April 9, 2019
BOARD OF COUNTY COMMISSIONERS
ORANGE COUNTY, FLORIDA
Addendum No. 3, IFB Y19-744-RC
MAGNOLIA PARK & ECO-TOURISM UTILITY EXTENSION

Bid Opening Date: April 18, 2019

NEW POWER EQUIPMENT RACK EXISTING E-ONE LIFT STATION #2
NOT TO SCALE

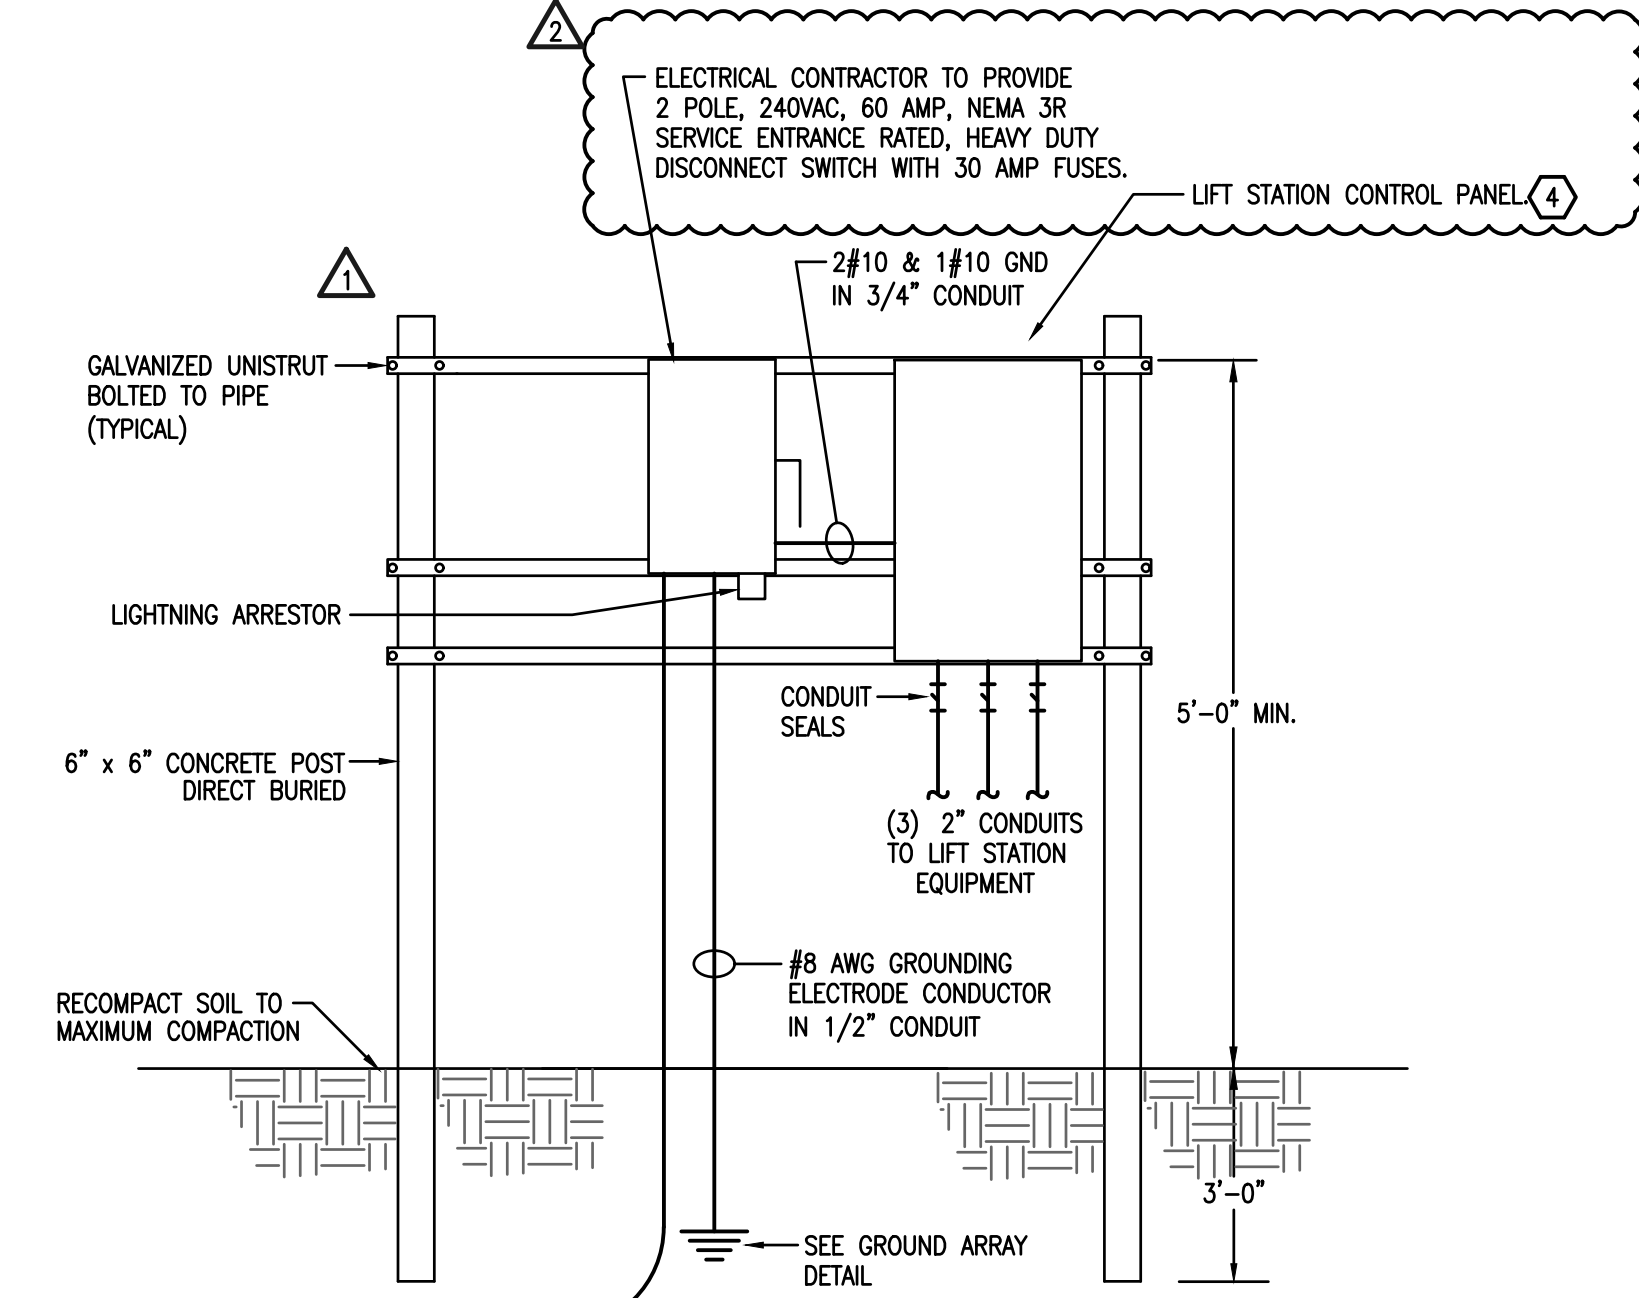
Answer: Yes – the #6 wire is due to voltage drop
6. **Question:** I noticed from a site visit that Panel “B” from sheet E001 that is intended to feed E-one lift station #2 is falling off of the wood, and may not be able to be reattached securely. Should we include a price for repairing this rack?

7. **Question:** The power equipment rack details for the E-one lift stations on sheet E001 show a 60 Amp disconnect with 30 amp fuses and a 30 amp breaker in the panel. The panel schedule on sheet E301 shows 40 amp breakers being added to feed the lift stations. Are the 60 amp disconnects needed for possible future upgrades? Which breaker size is to be used?

Answer: Based on the contractor’s claim that the panel is falling off of the wood backing we are adding a note to the plan calling for new PT wood backing for this panel and the meter. See revised sheet E001.

Answer: The panel schedule was corrected on sheet E001 to 30 amps from 40 amps. The 60 amp disconnect is called out in the cut sheet from the Lift Station provider. We have contacted the Lift Station provider and we have determined that the disconnect is to be provided by the electrical contractor and not by the Lift Station provider. See revised sheet E001.

1 SITE PLAN
 ES101 1" = 30'-0"

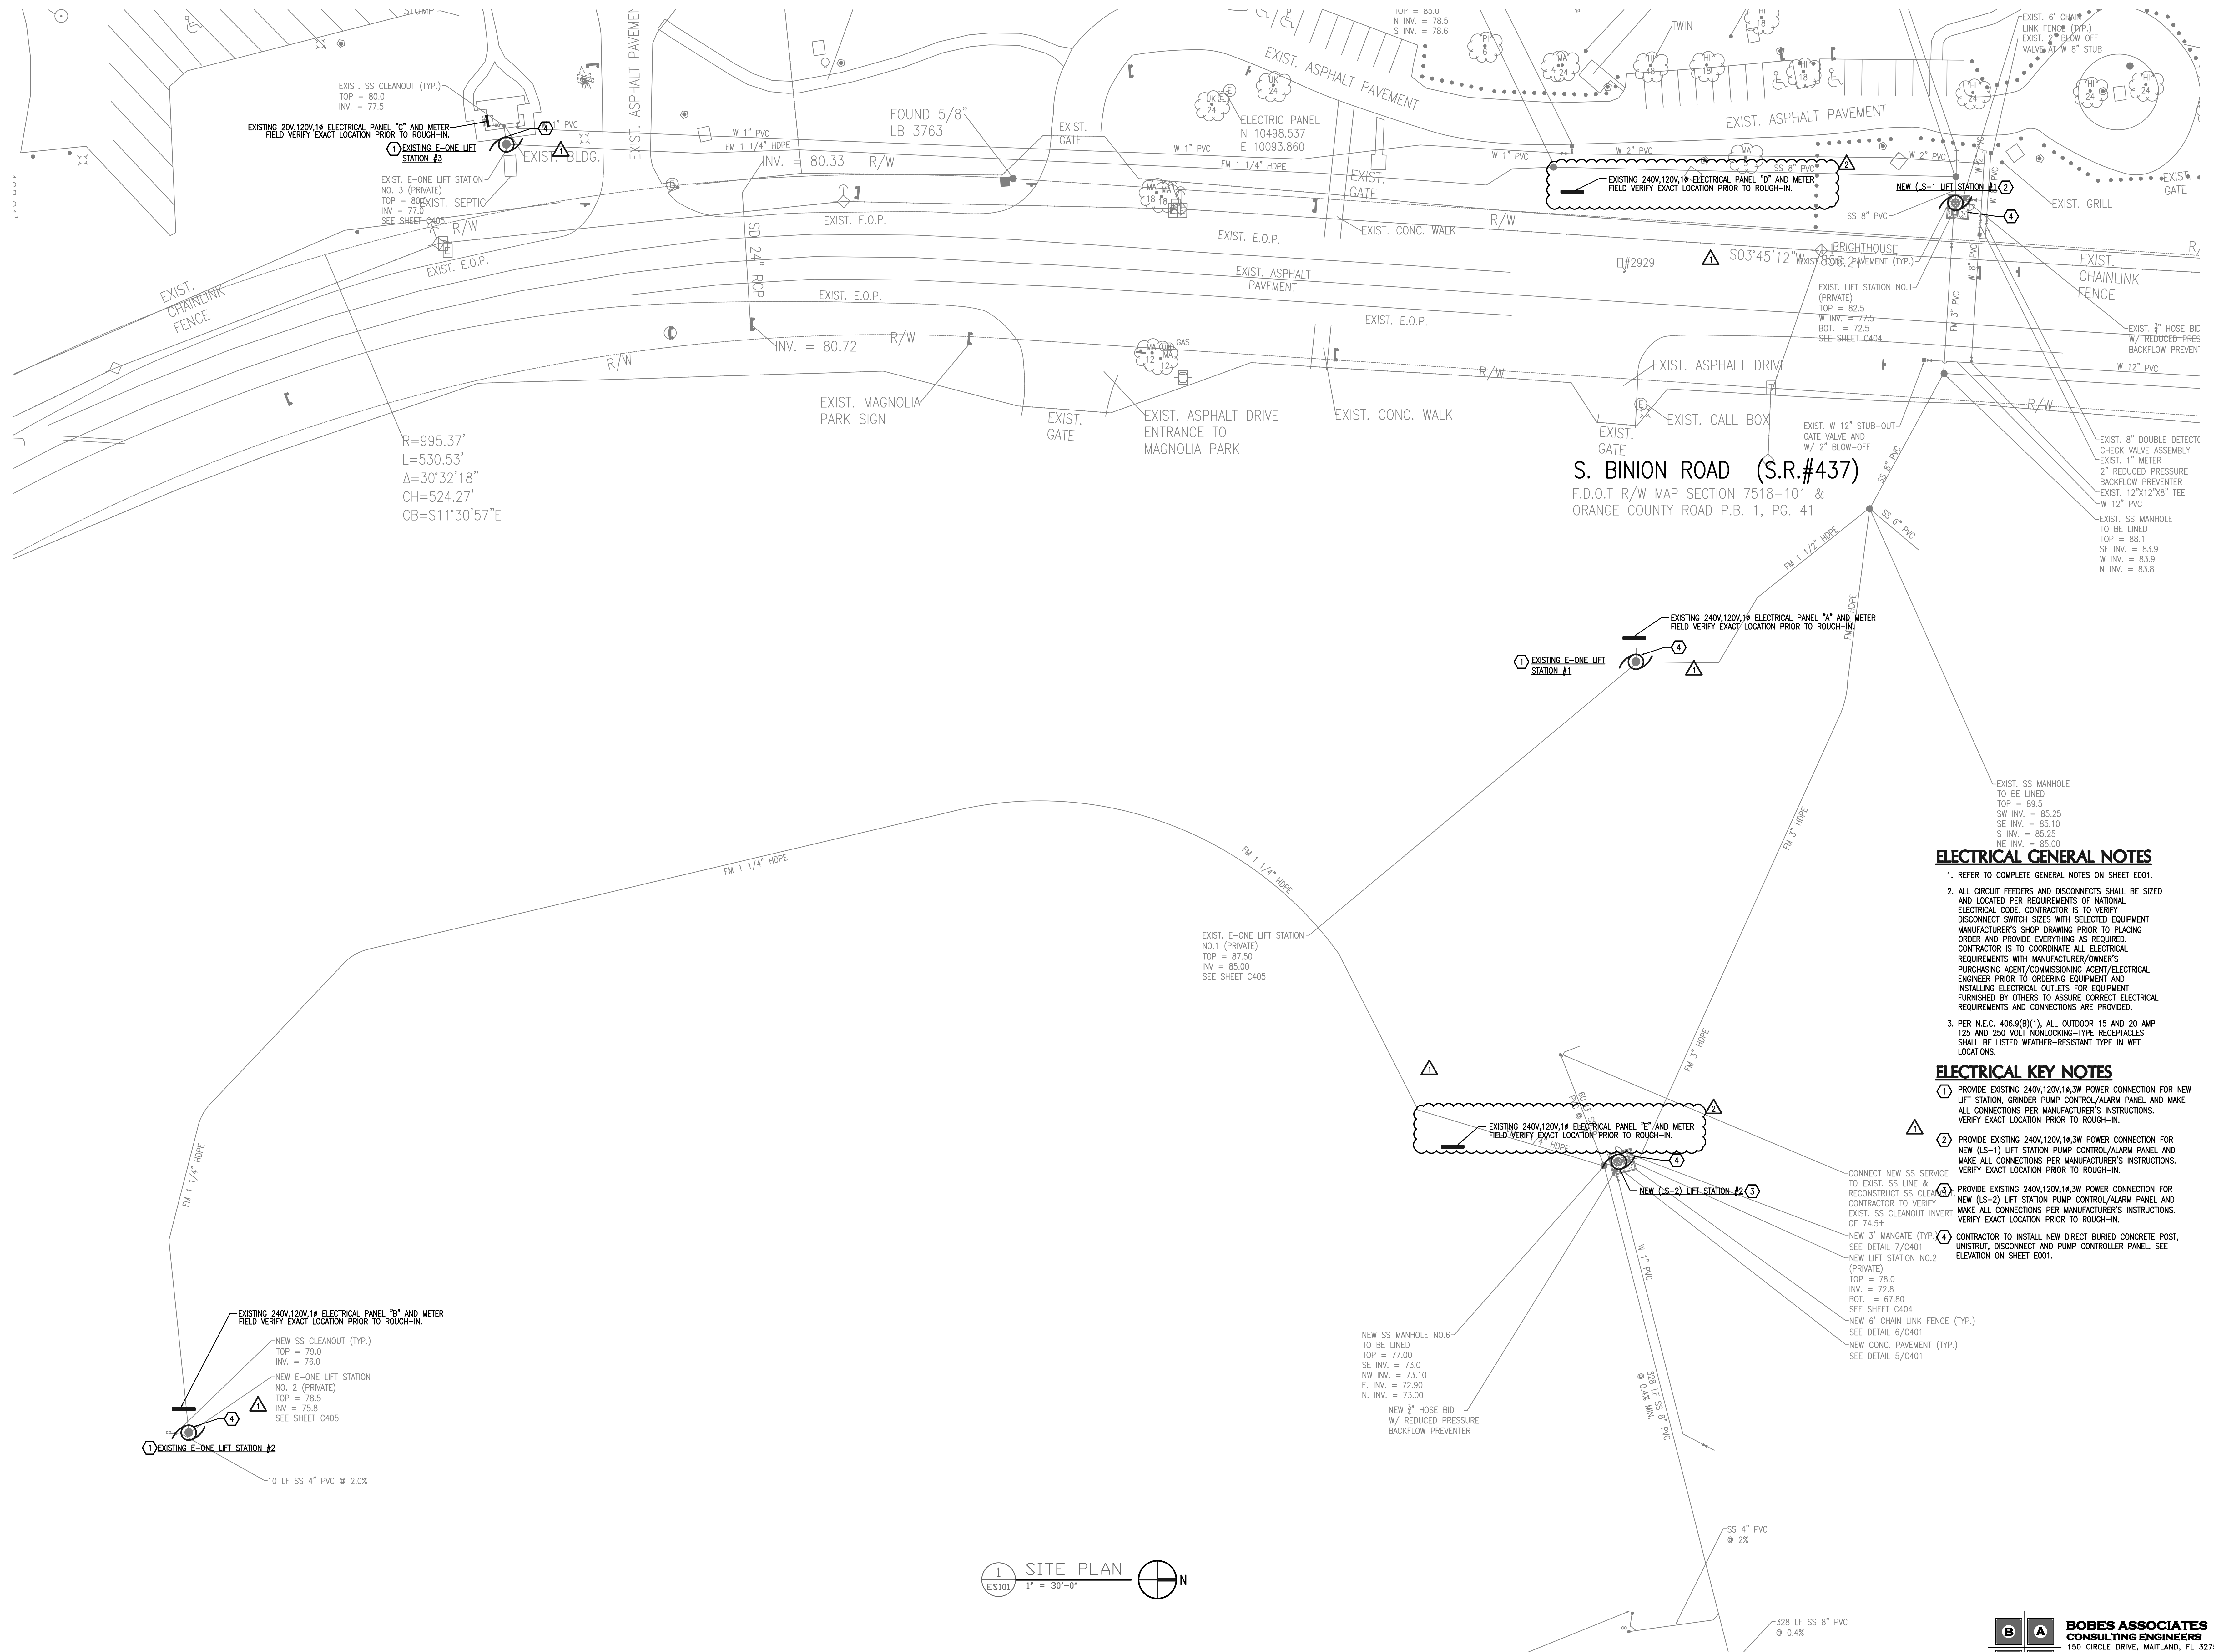
3. **Revision:** Sheet ES101 has been revised, with a revision date of 4/8/19.
4. **Question:** The new sheet E001 shows Lift station #1 being fed from Panel “D” and Lift Station #2 being fed from Panel “E”. The new sheet ES101 shows the lift stations being fed from the opposite panel.

Answer: This was corrected to address this item. See revised sheet ES101
5. **Question:** Is the #6 wire used to feed Lift Station #2 just for voltage drop?
